**Re: Petition of PPL Electric Utilities Corporation for Approval of a Major Modification to its Existing Long-Term Infrastructure Improvement Plan
Docket No. P-2022-3034972**

PPL Electric respectfully submits this letter in reply to the OCA's Comments and addresses the questions and requests set forth in the OCA's Comments as follows.¹

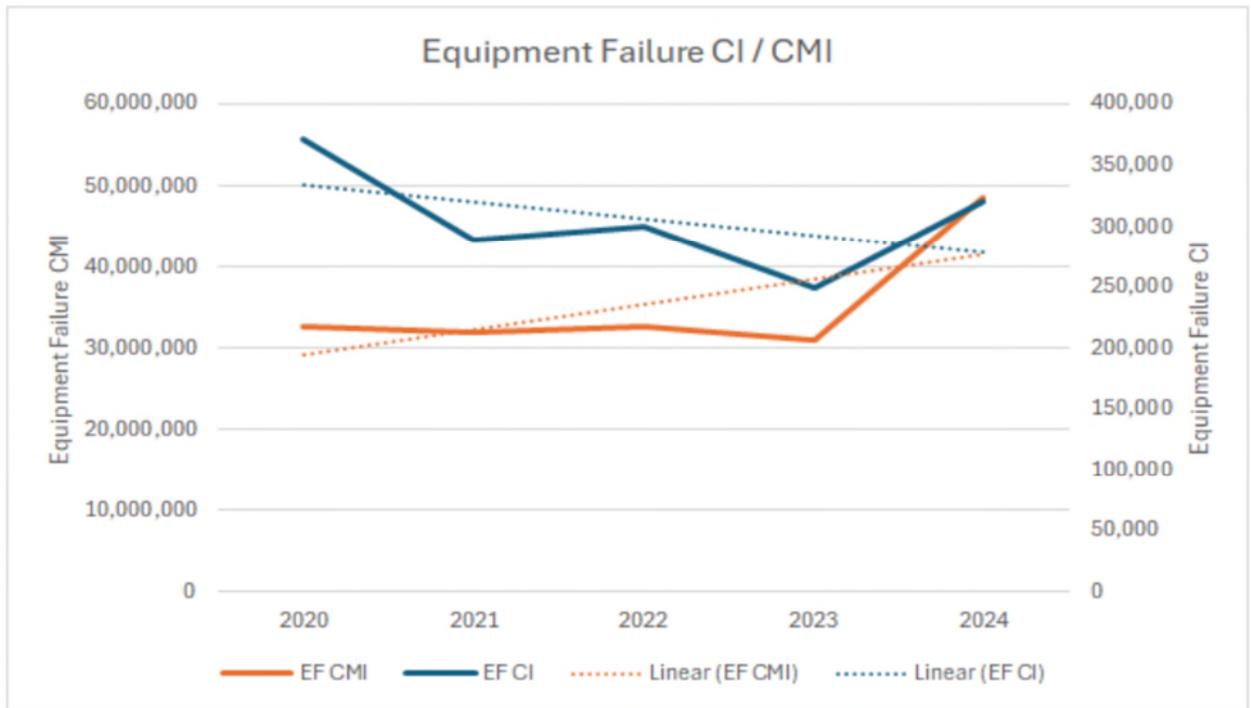
- e. Quantify the magnitude of the alleged increase in equipment-related outages (CI and CMI) over the last five years.

Response: Equipment failure related to CI and CMI are shown below. Trendlines are included. Note that while the 2020-2024 CI trend is decreasing, the period 2023 through YTD 2025 is showing an increase.
